MISSISSIPPI RIVER - GULF OUTLET

# NEW LOCK AND CONNECTING CHANNELS

## SITE SELECTION REPORT

SUBJECT: Mississippi River-Gulf Outlet--New Lock and Connecting Channels  
Site Selection Report

STEP NO.3 FILL EXCAVATION WITH SAND AND GRAVEL TO ABOVE CONFIGURATION AND PLACE 3 FOOT CLAY BLANKET ON CHANNEL SIDE OF SAND BACKFILL SLOPE

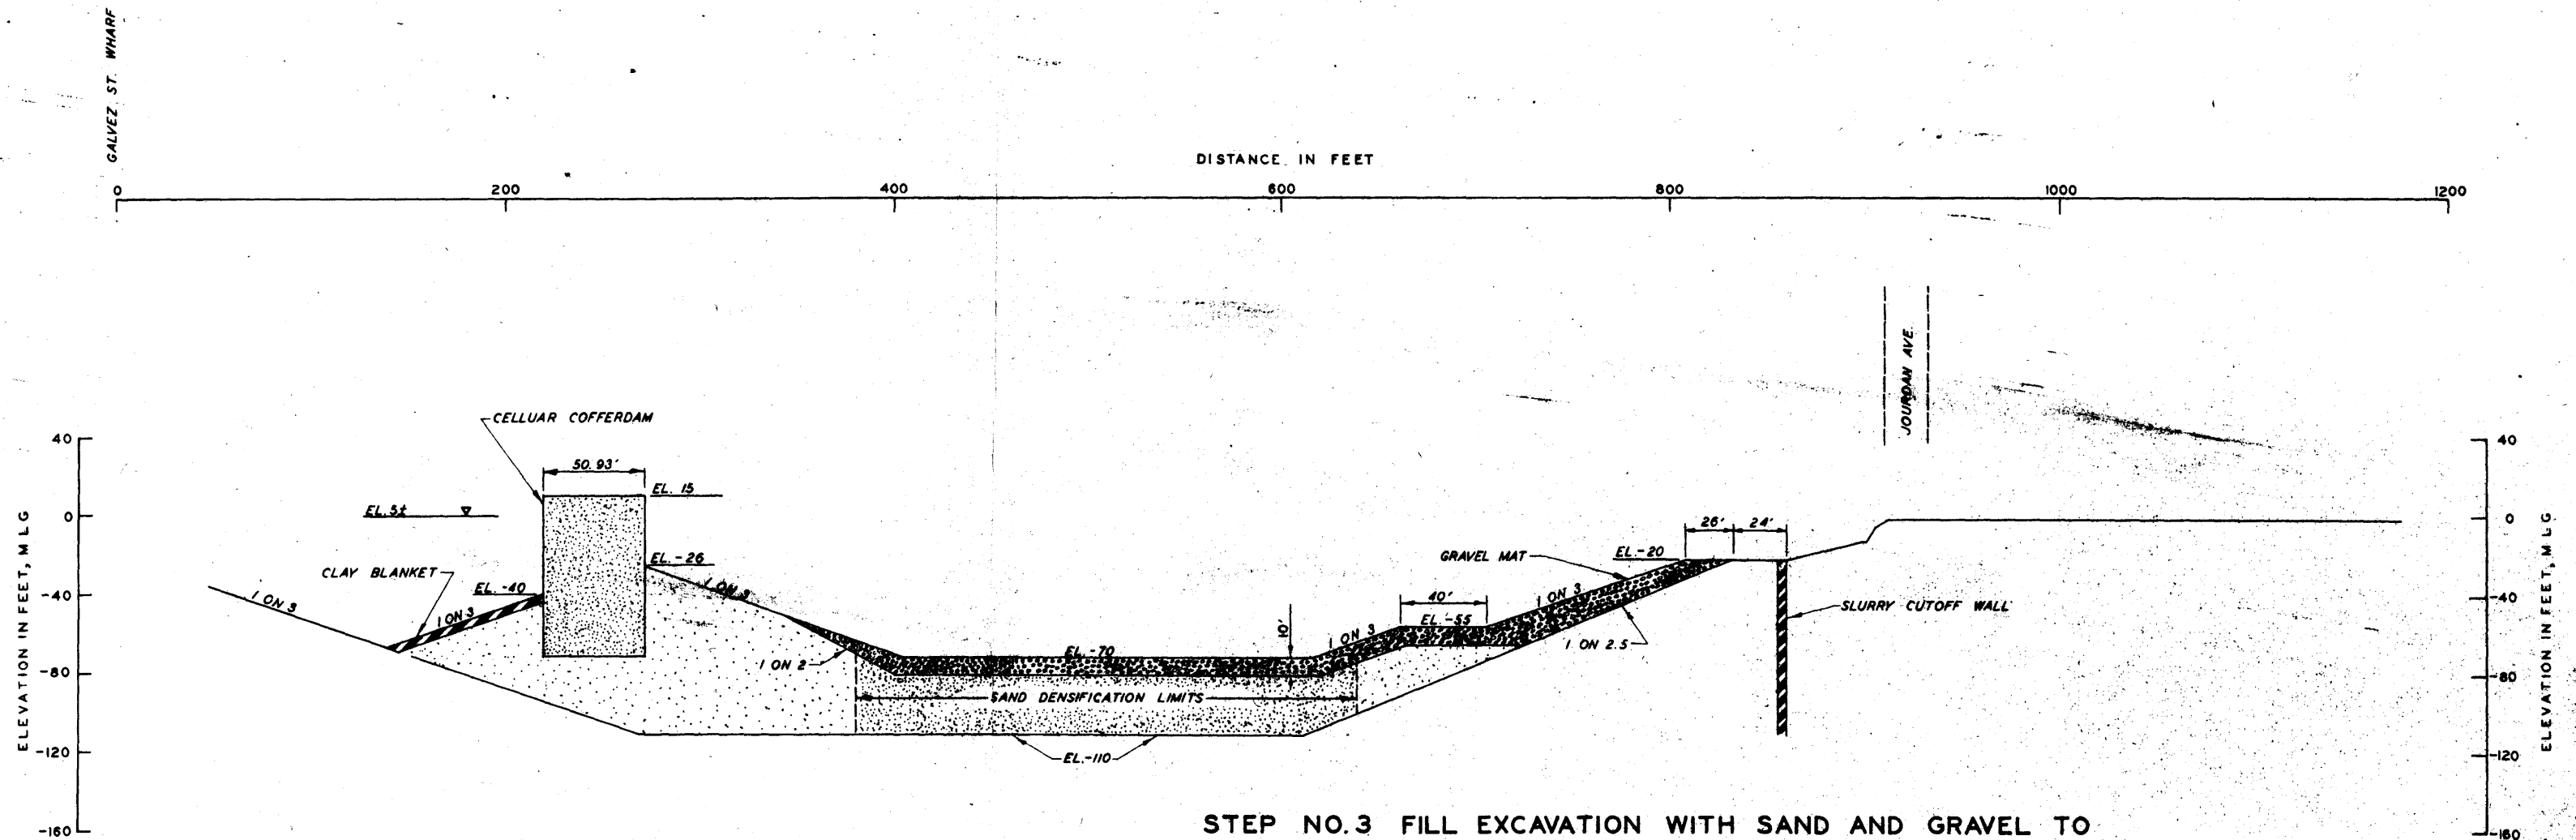
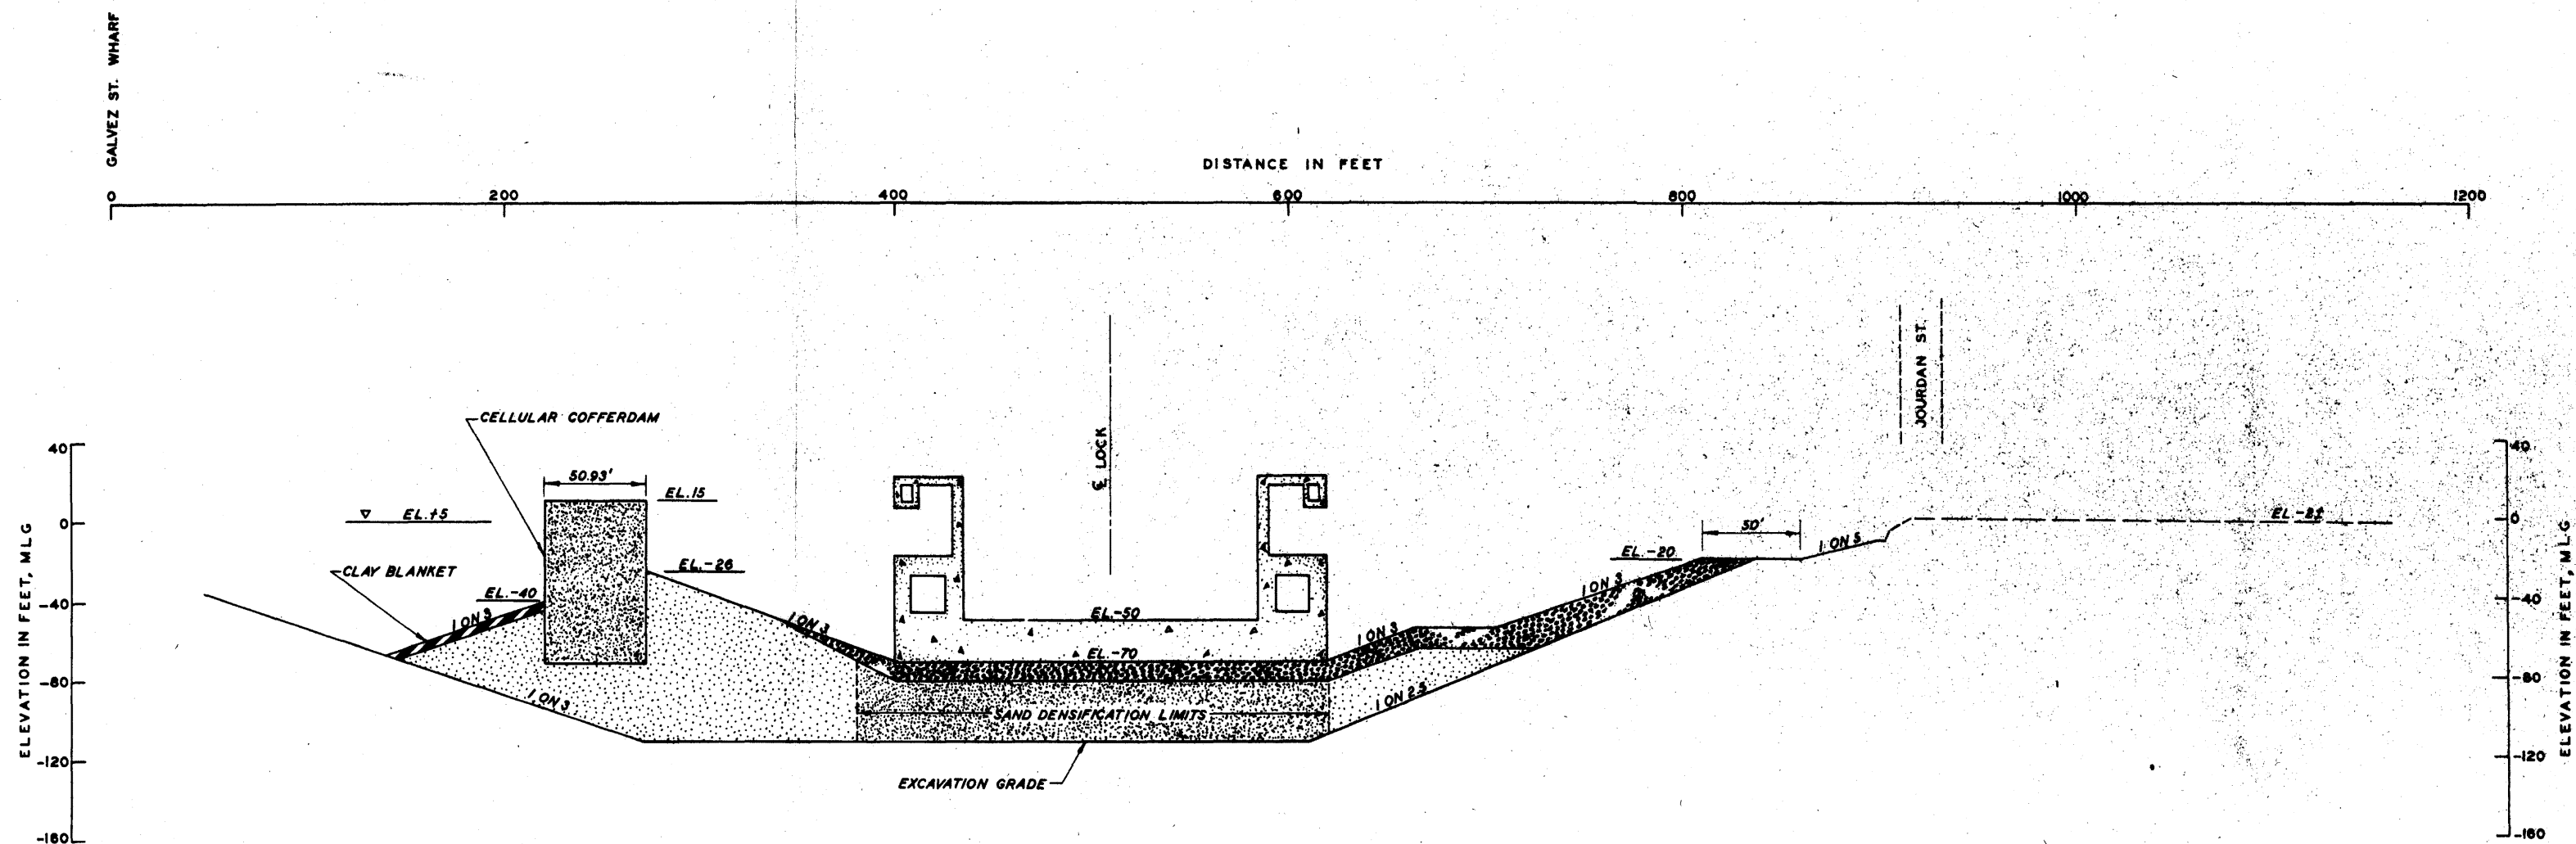
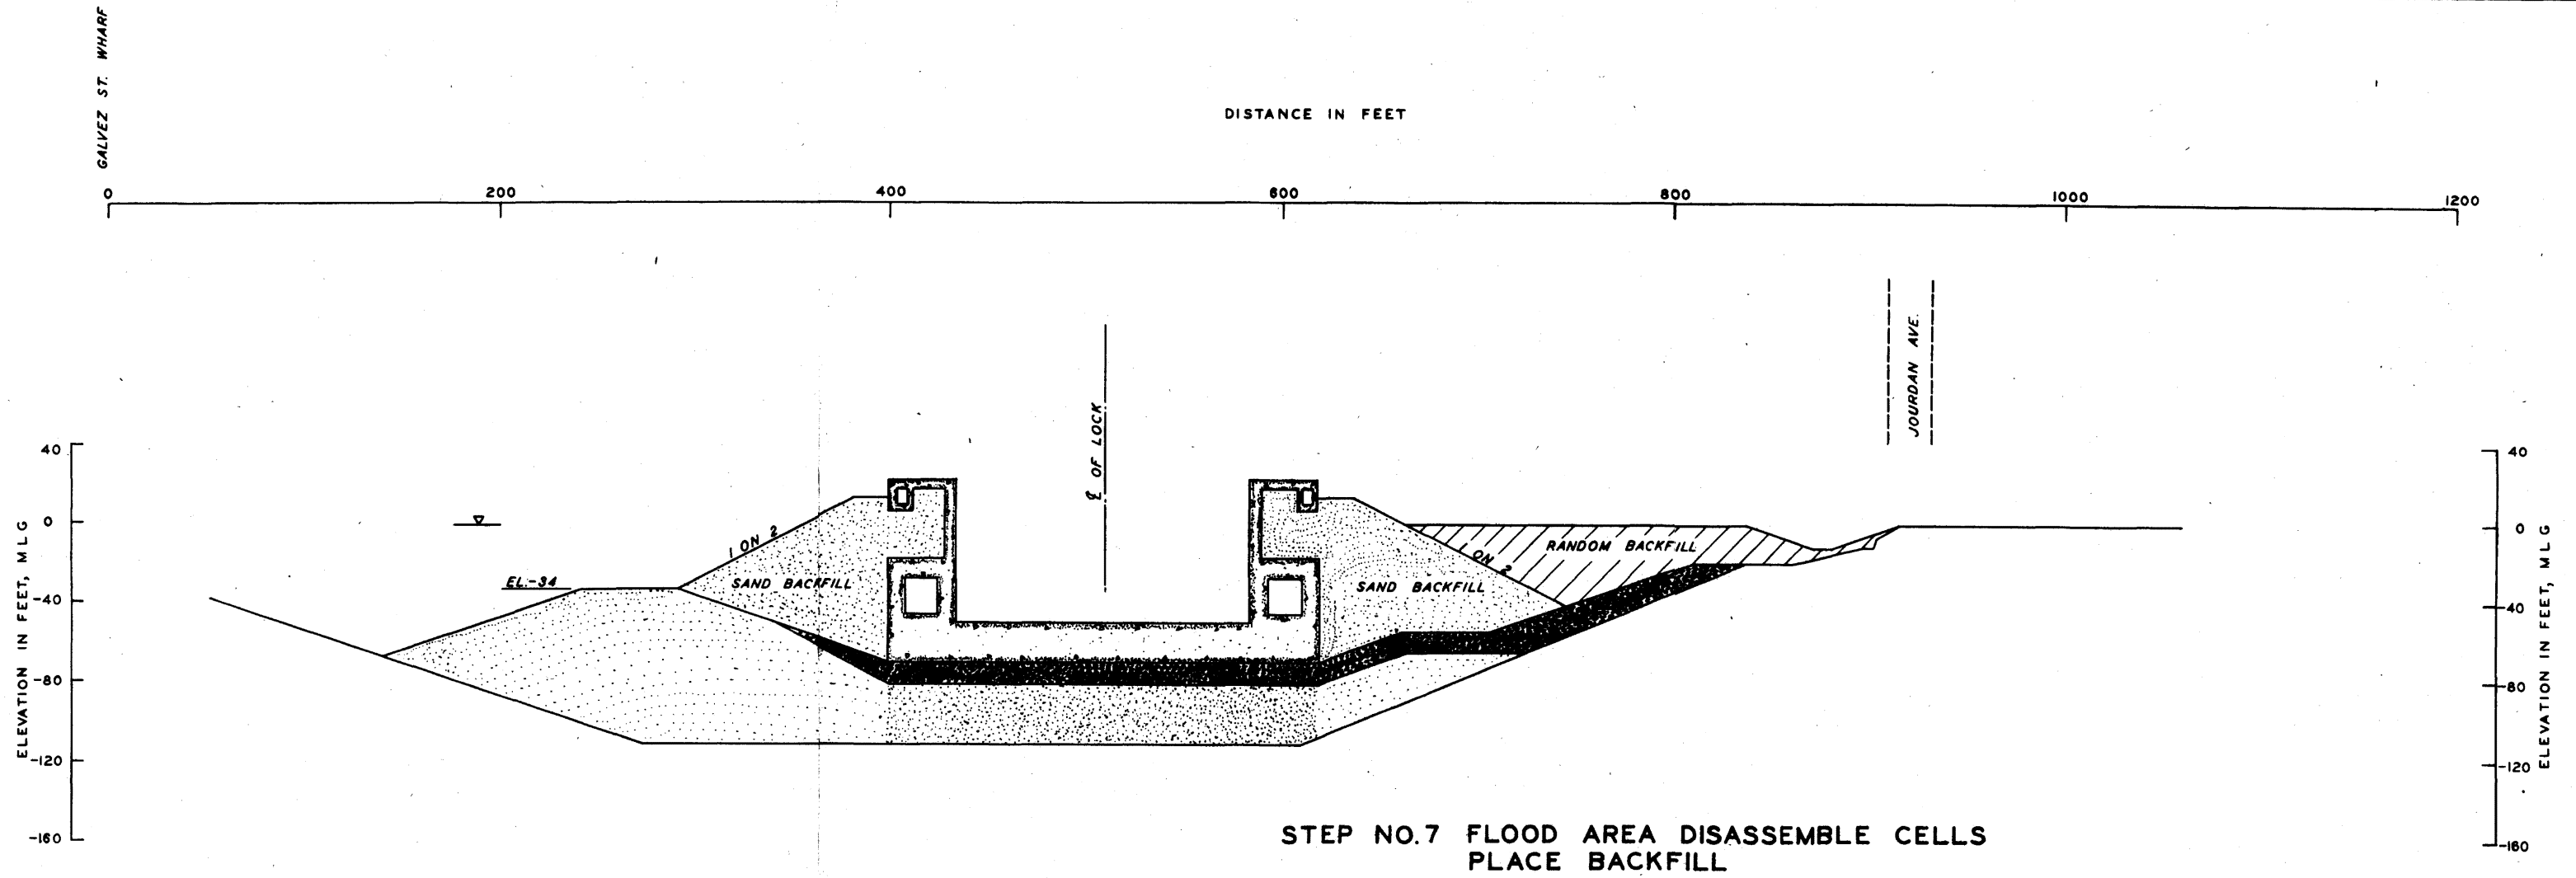
e. Para 4-03g and Plate IV-5. In the planned construction sequence, the excavation would be flooded before the sand backfill is placed. However, to permit adequate compaction, the backfill would have to be placed in the dry before the lock area is flooded.
